STAFF REPORT
COMMUNITY DEVELOPMENT DEPARTMENT

HEARING DATE: 5/25/2021
TO: Mayor & City Council
FROM: Joseph Dodson, Associate Planner
208-884-5533
SUBJECT: FP-2021-0029
Goddard Creek Townhomes

JOB NO. 21-087
SHEET 2 OF 4

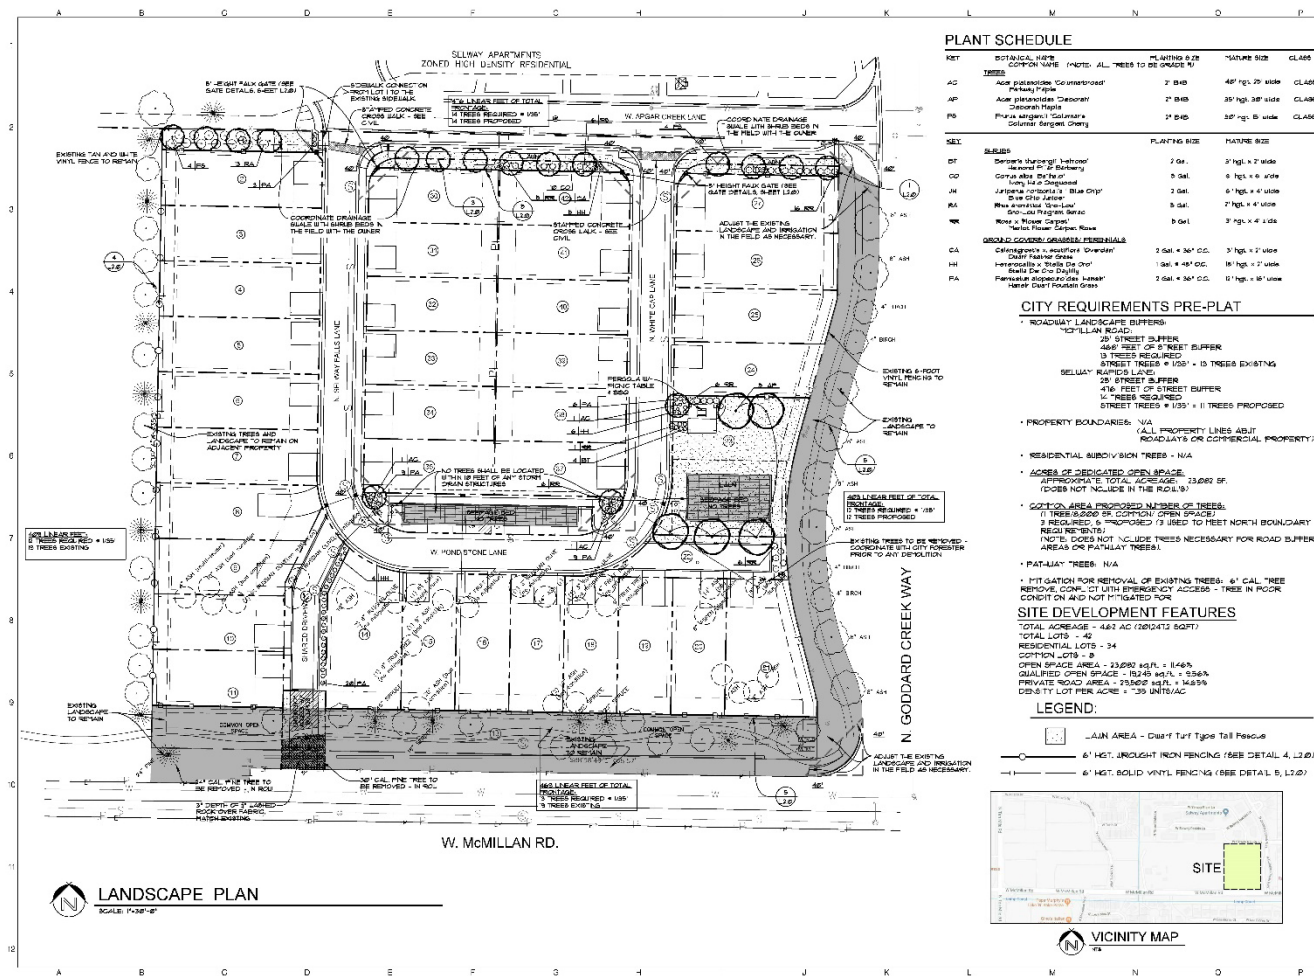
- a. Add plat note stating development is subject to the provisions contained within the City of Meridian Development Agreement, Inst. #2021-014149.
 - b. Add the Book and Pages for the adjacent subdivisions noted on sheet 1 of the Final Plat.

D. Common Drive Exhibit (Lots 12 and 22)

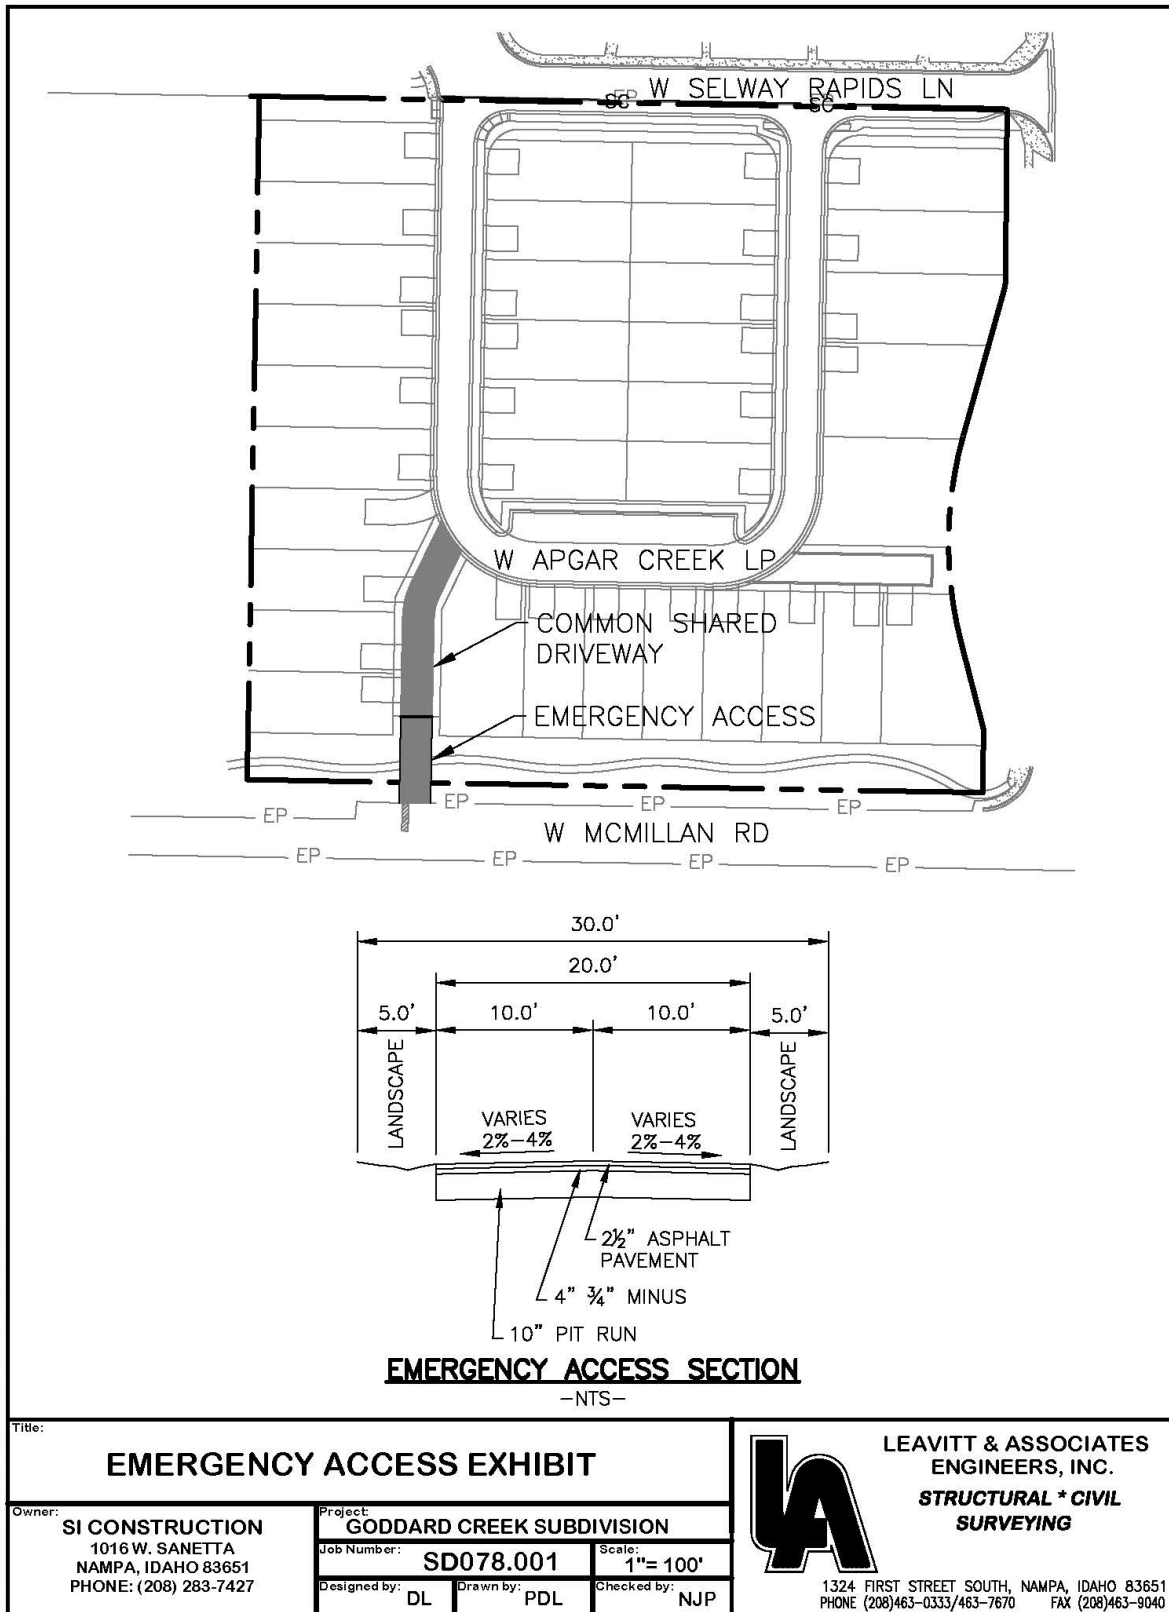
- a. Add an additional section of stamped concrete between the Lot 12 common drive/emergency access and the internal sidewalk adjacent to Lot 35 due to this common drive acting as the sidewalk connection to the arterial sidewalk along McMillan Road.

8. A perpetual ingress/egress easement shall be filed with the Ada County Recorder for the common driveway that also functions as an emergency access (Lot 12), which shall include a requirement for maintenance of a paved surface capable of supporting fire vehicles and equipment. A copy of the recorded easement shall be submitted to the Planning Division prior to signature on the final plat by the City Engineer.
